# REQUEST FOR COUNCIL ACTION

AGENDA SECTION: PUBLIC HEARINGS	ORIGINATING DEPT: PLANNING	ITEM NO. <b>E-6</b>
ITEM DESCRIPTION: Land Subdivision Permit (Preliminary Plat) #03-26 by Dallas M. Backhaus and Donna Rae Mann to be known as Wildwood Meadow. The Plat proposes to subdivide 20.09 acres of land into 45 lots for residential development and 1 outlot. The plat also proposes right-of-way dedication for public roadways. The property is located south of 37 <sup>th</sup> Avenue SE along the south side of 20 <sup>th</sup> Street SE.		PREPARED BY: Theresa Fogarty, Planner

## PRELIMINARY PLAT

**RE: Land Subdivision Permit (Preliminary Plat) #03-26 by Dallas M. Backhaus and Donna Rae Mann to be known as Wildwood Meadow. The Plat proposes to subdivide 20.09 acres of land into 45 lots for residential development and 1 outlot. The plat also proposes right-of-way dedication for public roadways. The property is located south of 37<sup>th</sup> Avenue SE along the south side of 20<sup>th</sup> Street SE.**

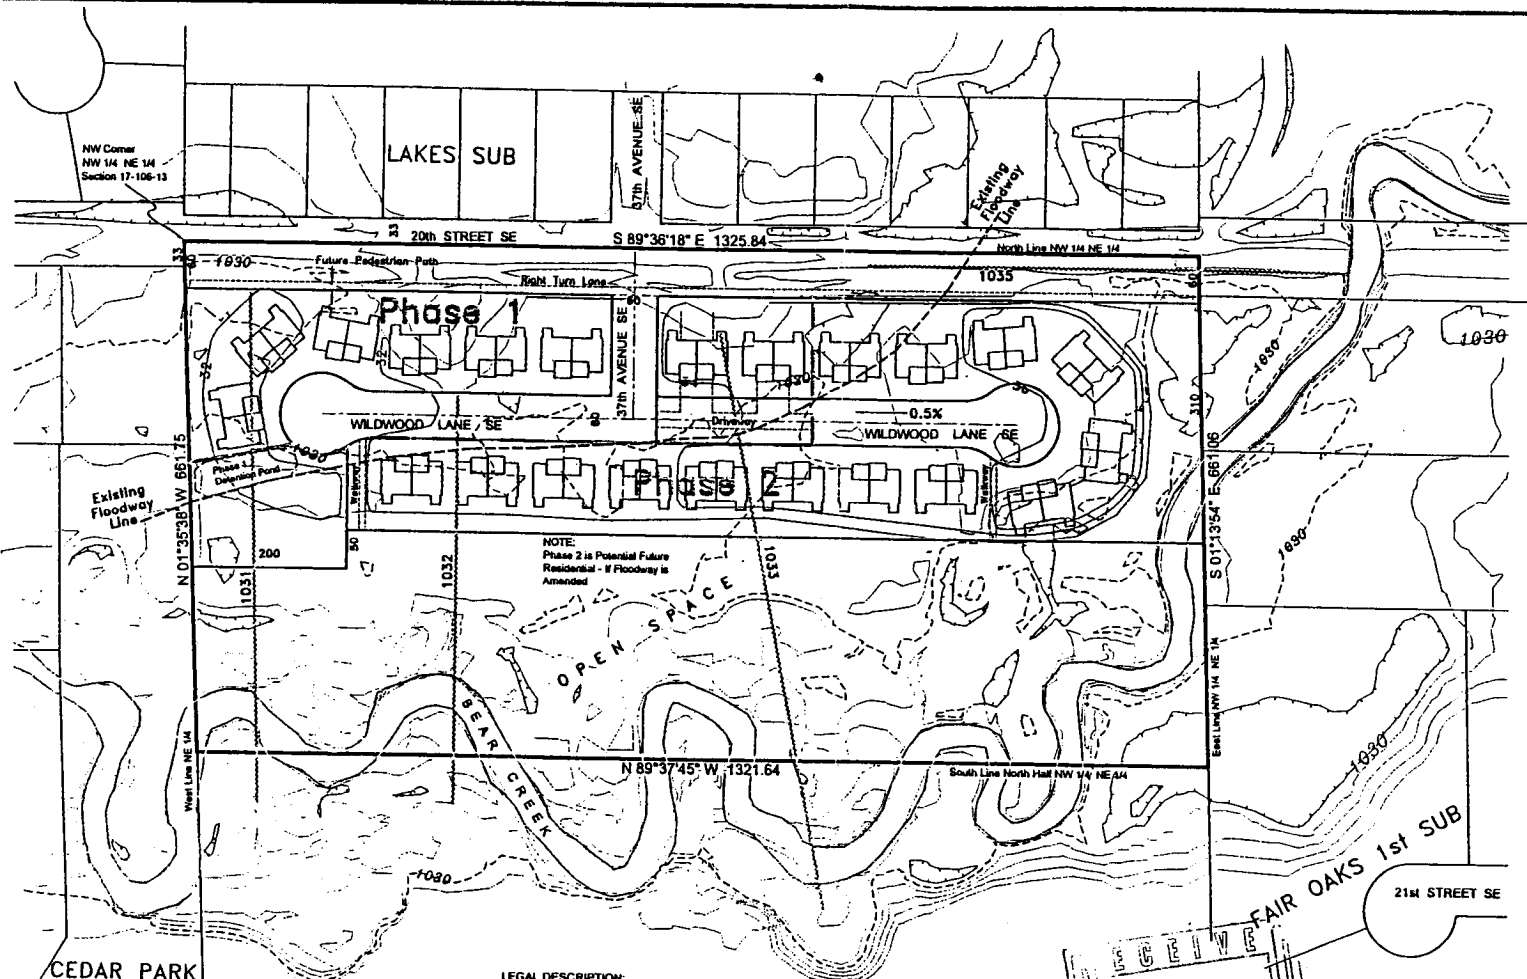
The third roadway identified as "Wildwood Lane SE" and is designed with a 50' right-of-way, ending in cul-de-sacs with a 51' radius. The use of the same roadway name on two cul-de-sacs cannot be accepted. It is recommended that one of the cul-de-sacs be renamed, keeping the roadway type Lane and directional of SE. An alternative street design for Wildwood Lane SE is required to address modifications to Wildwood Lane SE, that would be required if the Floodway Line is not modified to accommodate development as proposed on the preliminary plat.

An additional 10' wide utility easement will be needed along the west lot line of Lot 1, Block 1 and along the east lot line of Lot 29, Block 2.

An additional fire hydrant shall be placed on the corner of 37<sup>th</sup> Street SE and Wildwood Lane SE.

- 1. The Plat shall be revised, prior to the City Council hearing:**
  - a. Renaming one of the cul-de-sacs keeping the roadway type "Lane" and directional of "SE".**
  - b. Dedicating controlled access along the entire frontage of 20<sup>th</sup> Street SE, with the exception of the proposed local street access. In addition, controlled access shall be dedicated along the entire frontage on both sides of 37<sup>th</sup> Avenue SE and within 35 feet of the intersection of 37<sup>th</sup> Avenue SE and Wildwood Lane SE.**

- c. *Dedicating a 10' wide utility easement along the west lot line of Lot 1, Block 1 and along the east lot line of Lot 29, Block 2.*
  - d. *Dedicating an outlot(s) for all permanent detention facilities.*

- e. *Label the 100 year flood elevation boundary.*
2. *Grading and Drainage Plan approval is required prior to submitting the Final Plat. A Storm Water Management Fee will apply for the benefit of participation in the City's Storm Water Management Plan (SWMP) for any areas of this property that are not served by on-site detention, and are permitted to participate in the City's SWMP.*
